Product Discontinuation Notices

No. 2009243E

Discontinuation Notice of Field Network Products. DRT1 series

Dimensions

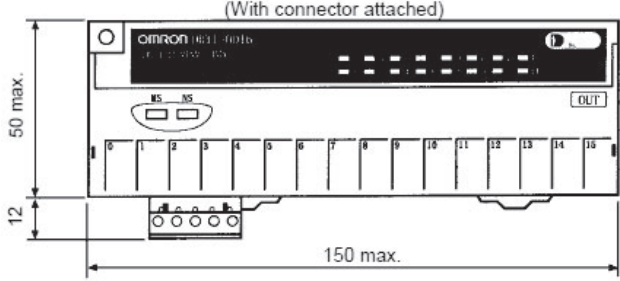
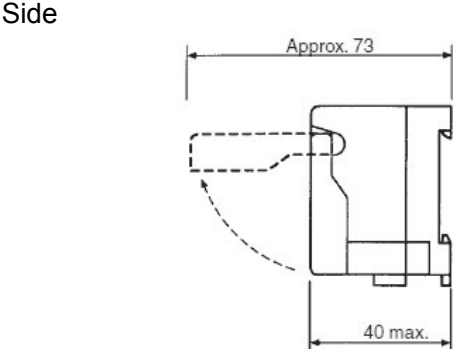
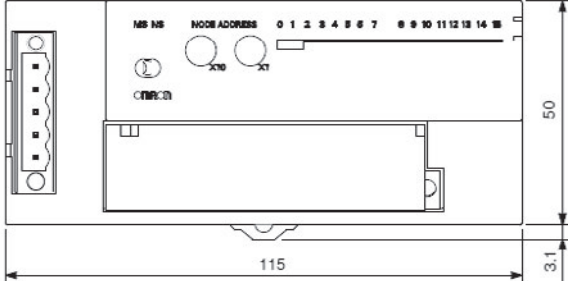
Product discontinuation	Recommendable replacement
<p>Front</p> <p>(With connector attached)</p>  <p>Side</p> 	<p>Front</p>  <p>Side</p>

Wire Connection

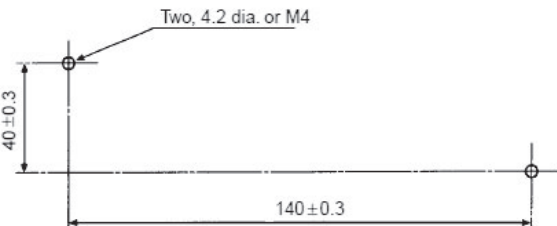
Product discontinuation	Recommendable replacement
<p>DRT1-ID16</p> <p>Diagram showing connections for DRT1-ID16. It includes an internal circuits power supply, an I/O power supply (24V DC), and three sensors: two NPN output 3-wire sensors (photoelectric or proximity) and one 2-wire sensor (limit switch). The terminal block has 22 terminals labeled 1 through 22.</p>	<p>DRT2-ID16</p> <p>Diagram showing connections for DRT2-ID16. It includes an I/O power supply (24V DC), a 3-wire sensor with NPN output (photoelectric or proximity), and a 2-wire sensor (e.g., limit switch). The terminal block has 18 terminals labeled 1 through 18.</p>
<p>DRT1-ID16-1</p> <p>Diagram showing connections for DRT1-ID16-1. It includes an internal circuits power supply, an I/O power supply (24V DC), and three sensors: two PNP output 3-wire sensors (photoelectric or proximity) and one 2-wire sensor (limit switch). The terminal block has 22 terminals labeled 1 through 22.</p>	<p>DRT2-ID16-1</p> <p>Diagram showing connections for DRT2-ID16-1. It includes an I/O power supply (24V DC), a 3-wire sensor with PNP output (photoelectric or proximity), and a 2-wire sensor (e.g., limit switch). The terminal block has 18 terminals labeled 1 through 18.</p>

<p>DRT1-OD16</p> <p>Diagram showing connections for DRT1-OD16. It includes an internal circuits power supply, an I/O power supply (24V DC), and two actuators: a Solenoid and a Valve. The terminal block has 22 terminals labeled 1 through 22.</p>	<p>DRT2-OD16</p> <p>Diagram showing connections for DRT2-OD16. It includes an I/O power supply (24V DC) and two actuators: Solenoid valve, etc. The terminal block has 18 terminals labeled 1 through 18.</p>
<p>DRT1-OD16-1</p> <p>Diagram showing connections for DRT1-OD16-1. It includes an internal circuits power supply, an I/O power supply (24V DC), and two actuators: a Solenoid and a Valve. The terminal block has 22 terminals labeled 1 through 22.</p>	<p>DRT2-OD16-1</p> <p>Diagram showing connections for DRT2-OD16-1. It includes an I/O power supply (24V DC) and two actuators: Solenoid valve, etc. The terminal block has 18 terminals labeled 1 through 18.</p>
